APPLICATION NO.	FILING DATE	FIRST NAMED INVENTOR	ATTORNEY DOCKET NO. CONFIRMATION N	
10/567,891	02/08/2006	Henning Von Spreckelsen	FIL-001	7288
22832 K&L Gates LLI	7590 06/08/201 P	EXAMINER		
STATE STREE One Lincoln Str	T FINANCIAL CENT	HYLTON, ROBIN ANNETTE		
BOSTON, MA		ART UNIT	PAPER NUMBER	
			3781	
			MAIL DATE	DELIVERY MODE
			06/08/2010	PAPER

Application No.	Applicant(s)			
	10/567,891	VON SPRECKELSEN ET AL.			
Office Action Summary	Examiner	Art Unit			
	ROBIN HYLTON	3781			
The MAILING DATE of this communication app Period for Reply	ears on the cover sheet with the c	orrespondence address			
A SHORTENED STATUTORY PERIOD FOR REPLY WHICHEVER IS LONGER, FROM THE MAILING DA - Extensions of time may be available under the provisions of 37 CFR 1.13 after SIX (6) MONTHS from the mailing date of this communication. - If NO period for reply is specified above, the maximum statutory period w - Failure to reply within the set or extended period for reply will, by statute, Any reply received by the Office later than three months after the mailing earned patent term adjustment. See 37 CFR 1.704(b).	ATE OF THIS COMMUNICATION 36(a). In no event, however, may a reply be time will apply an

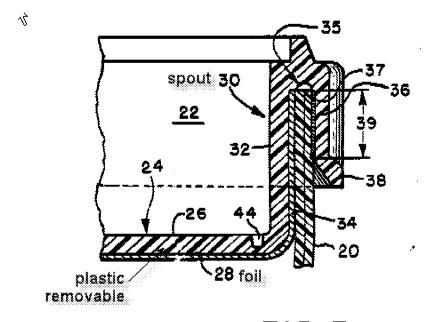
Claim 18 recites the limitation "the periphery of the removable part" in line 9. There is insufficient antecedent basis for this limitation in the claim.

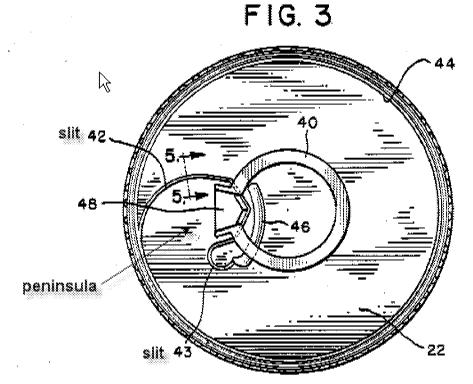
In claim 9, the phrase "passing close to and beyond a center" is unclear since an extension beyond a center must pass close to the center.
